DESIGN DS	DRAWN BY DS	DART AEROSPACE LTD VICTORIA INTERNATIONAL AIRPORT, CANADA	
CHECKED DS	APPROVED DS	DRAWING NO. DEO 9094	REV. A SHEET 1 OF 1
DATE 97.10.22		TITLE TOW RING DRILLING CHANGE	SCALE NTS

## DART ENGINEERING ORDER

TO AMEND DRAWINGS : D2580 REV. B  
D2590 REV. B

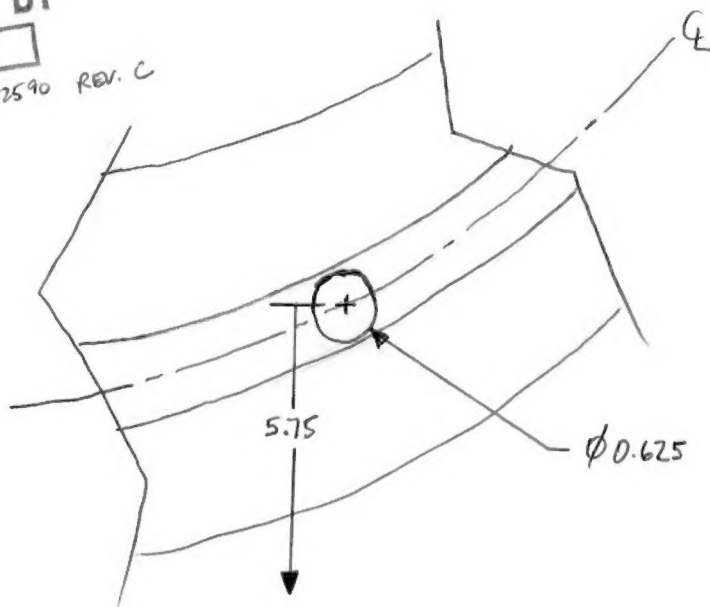
- DRILL TOW RING HOLE IN SAME LOCATION SPECIFIED BY DRAWINGS D2580 AND D2590.
- DRILL TO NEW DIAMETER OF 0.625
- DO NOT WELD IN D2579 CROSS BOLT SPACER
